Planning Commission Staff Report

Subject: Treasure
Project #: PL-08-00370
Authors: Francisco Astorga, AICP, Senior Planner
Bruce Erickson, AICP, Planning Director
Date: 11 October 2017
Type of Item: Administrative – Conditional Use Permit
Refinement 17.2 Update / Planning Commission
Outstanding Items

Refinement 17.2 Update

SHEET NO.
COMPOSITE
E4B.1

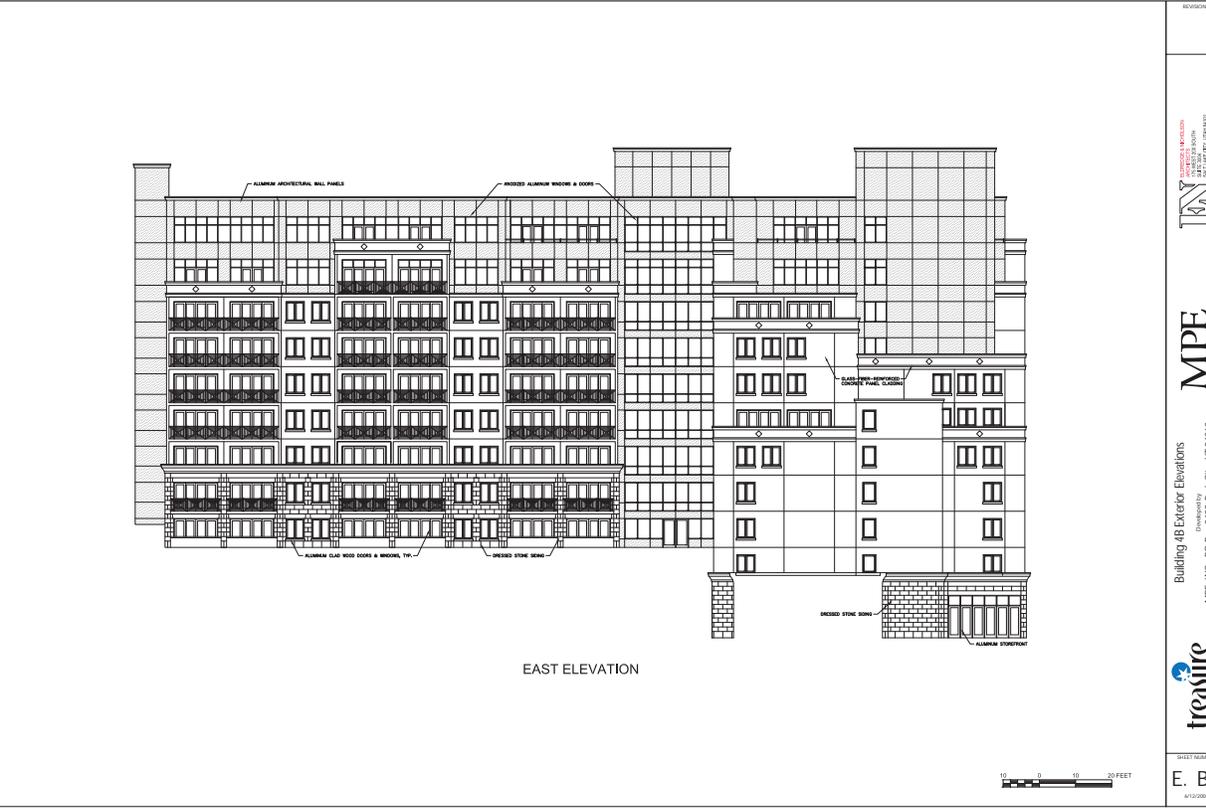
- Building 4B Exterior Elevations ([Sheet No. E4B.1 - comparative](#)) notes:
 - Minimal changes shown with the 2009 building outlined compared to show difference.

SHEET NO.
COMPOSITE
E4B.2

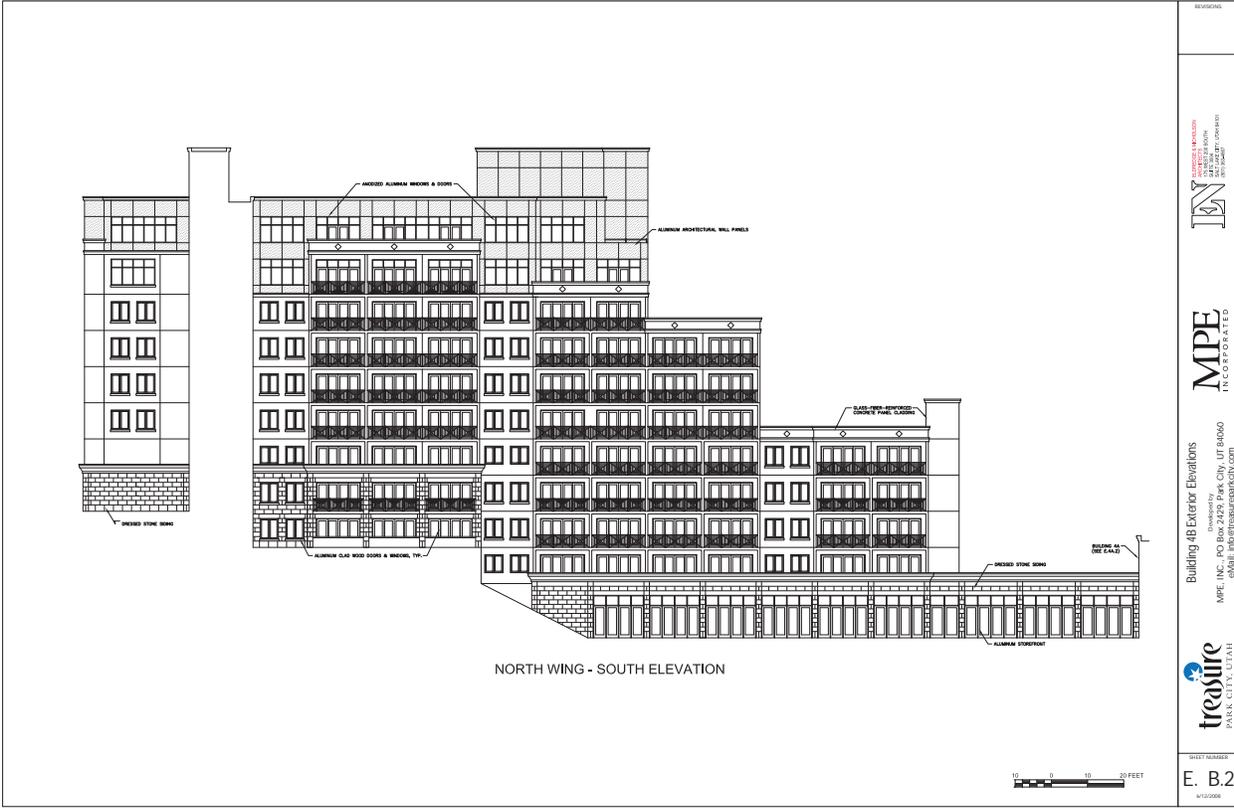
- Building 4B Exterior Elevations ([Sheet No. E4B.2 - comparative](#)) notes:
 - Major changes shown with the 2009 building outlined compared to show difference.
 - Several storied added at different location of building 4B changing its massing.
 - Reduced width of link between Buildings 4A & 4B/.
 - Building Elevation raised to accommodate existing grade at Lowell-Empire loop.
